NFPA 805 OBSERVATION VISIT TRIP REPORT

Location: Oconee Nuclear Station, Seneca, South Carolina

Subject: Risk-Informed, Performance-Based Fire Protection Transition Pilot-Plant
Observation Visit - Oconee Nuclear Station

Figure 1. Multiple Spurious Post-Transition Inspections

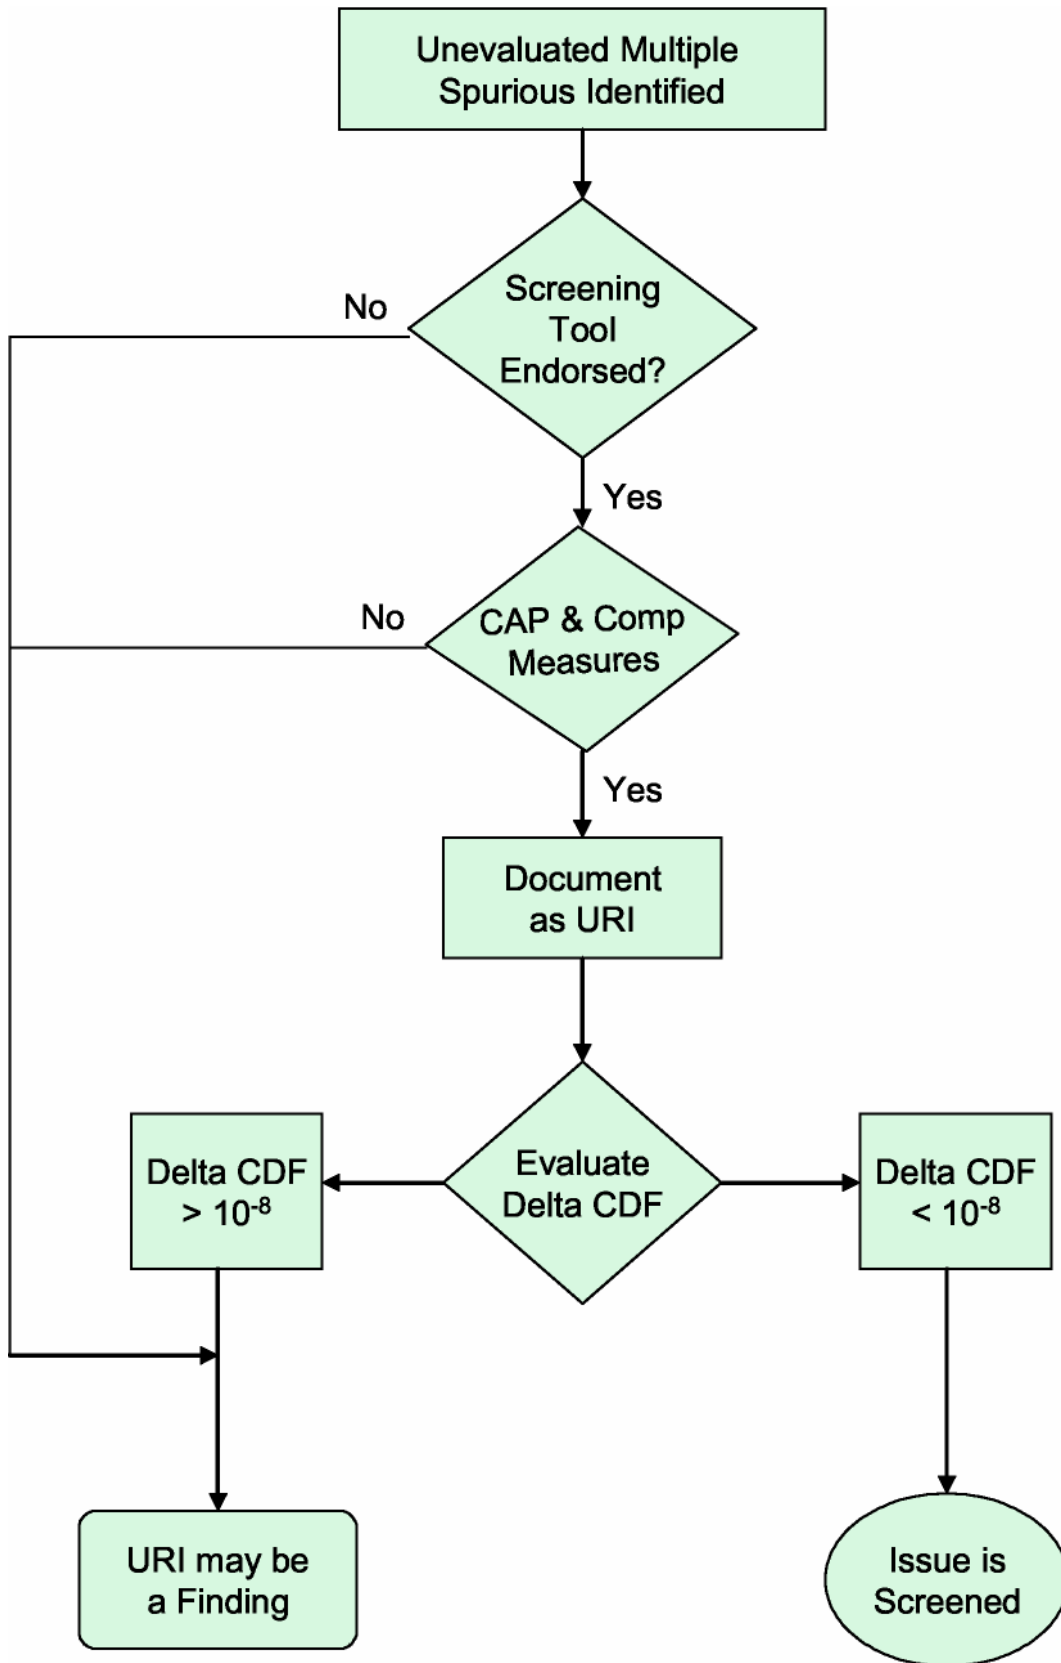
Status: OPEN. The November 2005 pilot-plant observation visit initially identified this issue. The NRC Staff reviewed the ROP relative to the treatment of newly identified multiple spurious operations that have unknown risk significance.

At the March 2006 pilot plant observation visit, the Staff presented a flow chart, illustrating how newly found multiple spurious circuits identified during an inspections, could be treated (See flow chart below). In addition to the flowchart, the following information was discussed:

Resolution Action(s)/Action Party: OPEN. Industry and pilot-plant participants agreed to review the flowchart, IMC 0612 questions, screening thresholds and provide feedback to the NRC at the next observation meeting. The industry may also submit an FAQ on the issue.
